Beckfoot Priestthorpe School - Accessibility Action Plan.

Updated: 10/01/2025

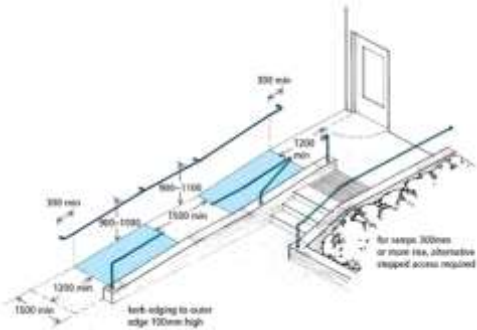
<p>16.6</p>	<p>An induction loop was not identified in the main hall. This is an area of the school that may be used for assemblies and performances. This area measured to be approximately 14080mm by 11040mm.</p>  <p>The image shows a blue square sign with a white ear icon and a white 'T' symbol. Below the icon, the text reads 'Induction Loop Available' and 'Please ask a member of staff'.</p>	<p>Install an induction loop to benefit hearing aid users. An induction loop or similar should be present at the premises where visitors are likely to experience presentations, meetings, training etc.</p> <p>It is a legal requirement under the Equality Act 2010 to provide auxiliary aids.</p> <p>Direct Access has a partnership with a world leading induction loop manufacturer to provide auxiliary aids for people with hearing impairments. Please contact the Direct Access Implementation Team for more details at info@directaccess.group or read more at https://directaccessgp.co.uk/induction-loops-and-hearing-enhancement-systems/</p> <p>According to BS8300 - A hearing enhancement system, using induction loop, infrared or radio transmission, should be installed in rooms and spaces used for meetings, lectures, classes, performances, spectator sport or films, and at service or reception counters where the background noise level is high or where glazed screens are used.</p>	<p>M</p>	<p>Portable.</p>

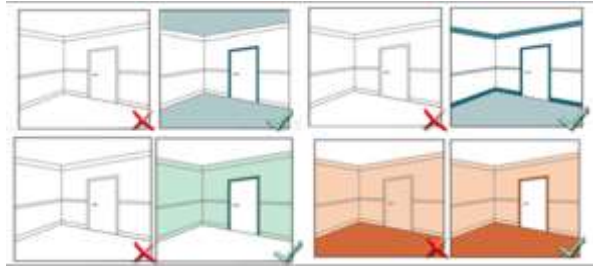
<p>5.4</p>	<p>Steps were required at the main entrance. The auditor was informed of potential future developments for this entrance to be ramped to avoid the extended route around the school. The height of the steps was approximately 1500mm.</p> <p>Signage was provided to direct people to an alternative entrance. The phrase “disabled access” requires changing.</p> <p>Steps were required into the trust area; the alternative entrance was not signposted from here.</p>	<p>The access limitations of the premises and the alternatives must be communicated via the website.</p> <p>Suitable signposting should be provided to direct disabled people to an alternative accessible entrance. Any signage provide should feature the access symbol and correct directional arrow. The alternative entrance must be open and available for use or have suitable procedures in place to provide assistanc</p>  <p>Should a ramp be constructed at the main entrance, it must comply with BS8300 and ADM-2:1.26 requirements. Any permanent ramp must be a maximum 1:12 over a maximum going of 2m, it should be a minimum 1.2m wide and feature 1.2m landings at head and foot, handrails to both sides and a contrasted sloped surface.</p>	<p>M/ST</p>

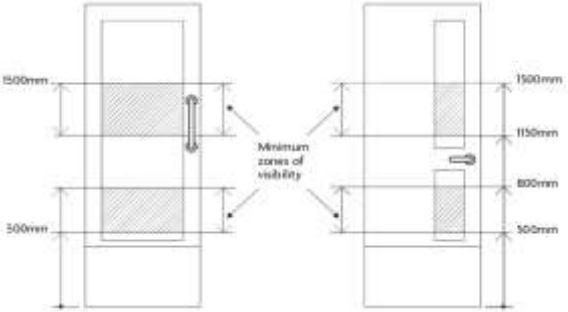
5.8	<p>The entry phone system was approximately 1450mm from ground floor level, which may not be accessible for people who are short in stature.</p> <p>The intercom at the accessible entrance was audio only. A camera was provided for reception to see this area; however, people who are Deaf or have hearing loss may find accessing this control difficult.</p> <p>The intercom at the main entrance was high from ground floor level and may not be accessible for all users.</p>	<p>Consider installing intercoms which have tactile definition to the buttons and an LED display. Ensure all operating parts are within 1050mm off the landing level and ensure no obstruction below. Ensure that it is well contrasted against the background upon which it is seen.</p> <p>Ⓜ Note AD M is not descriptive on intercoms and BS8300, best practice should be referred to. In all cases when installing intercoms specialist advice should be sought.</p> <p>Ⓜ BS8300 States - Entryphone systems should be sited for approach and use from a wheelchair and should contain a light emitting diode (LED) display to enable people who are deaf and hard of hearing to use them. the means of indicating that the call is acknowledged and that the lock has been released (if permitted) should be both audible and visible. the Entryphone system should contrast visually with the background.</p> <p>Where the entrance point does not provide a clear view of the reception area, make sure that a phone number or suitable alert and management system are in place to provide alternative access for anyone that cannot operate the intercom.</p>	M/N	CCTV in place, intercom is accessible.

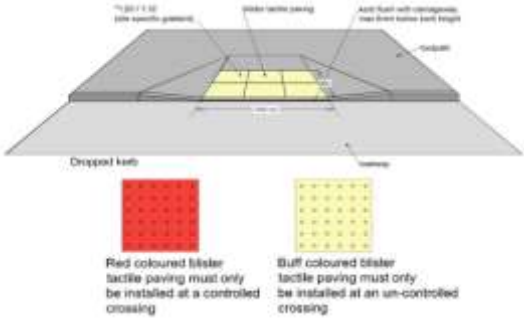
15.3	<p>The accessible WC facility in the hall was not signposted as a WC facility.</p> <p>The WC facilities near to the main hall featured signage for “girls cloakroom”, the auditor was informed that the WC facilities were changed to all students.</p> <p>The WC facilities near to the Trust stairwell did not feature signage.</p> <p>The accessible WC facility in nursery featured signage that was high from ground floor level and no tactile or braille information was provided.</p>	<p>The appropriate toilet signage should be provided. As well as signage on the toilet doors, there should also be signs indicating where the accessible WCs are located.</p> <p>Ideally, all accessible WC door signage to be accessible to all disabled people with Braille and embossed lettering preferred.</p> <p>BS8300 states - Information and direction signs should be provided at each point where they are required, e.g. at junctions of circulation routes, at key locations such as doorways and reception points, at facilities such as telephones and toilets, and in rooms, spaces and counters. The colour, design and typeface of signs should be consistent throughout a building.</p> 	M

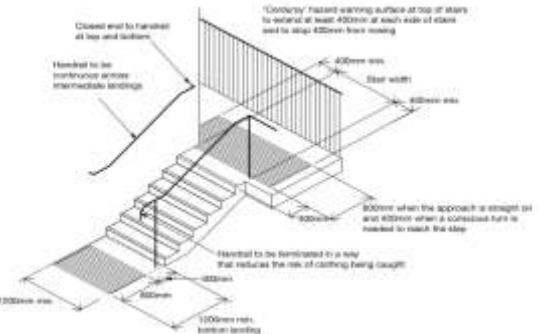
6.3	<p>The reception area was approximately 1000mm from ground floor level.</p> <p>The sign in screen as approximately 1170mm.</p> <p>A stepped entrance is required from the main entrance to access this area. An alternative, extended route is provided.</p>	<p>The reception should be designed to accommodate both standing and seated customers with at least one section of the counter 1500mm wide, with its surface no higher than 760mm, and a knee recess 500mm deep up to a height of 700mm.</p> <p>It is recommended to lower the sign in screen to a height that is suitable for approach from both standing and seated users.</p>	M
